Customer Service Bulletin
Commercial Business Group

Greensmaster® 1000 \ 1600

Subject: Light Kit (04059) Rework.

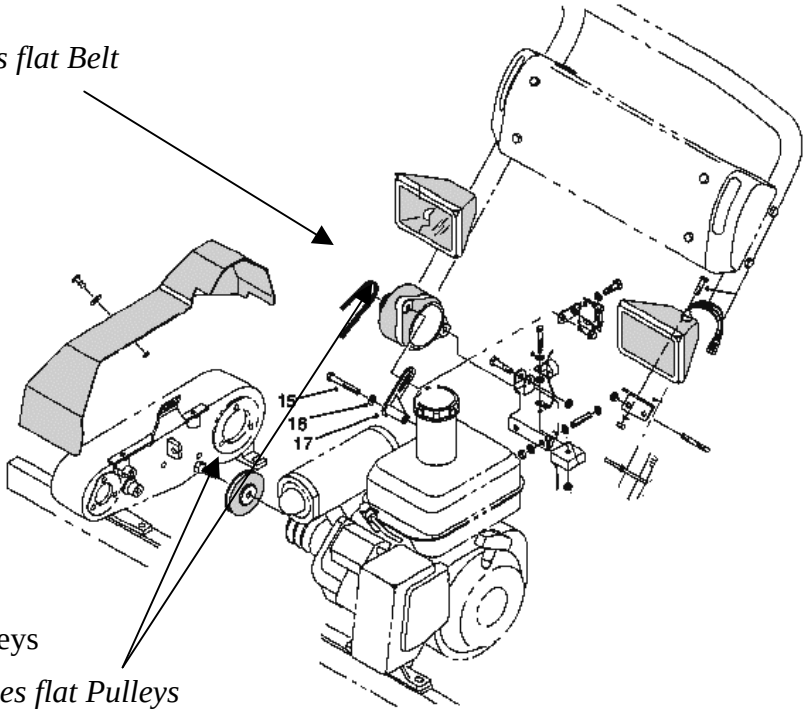
Light Kit (04059) was designed with a Flat Belt to drive the generator. If any misalignment between the Engine and Generator pulley exists, the belt can fail prematurely. All Light Kits (04059) will be reworked by your TORO distributor by installing Pulley Update Kit (98-5923). This kit will include a new 2L section V-belt and V-pulleys to replace the Flat Belt and Flat Pulleys. Contact your local TORO distributor to arrange for repairs.

V-Belt

Replaces flat Belt

V-Pulleys

Replaces flat Pulleys
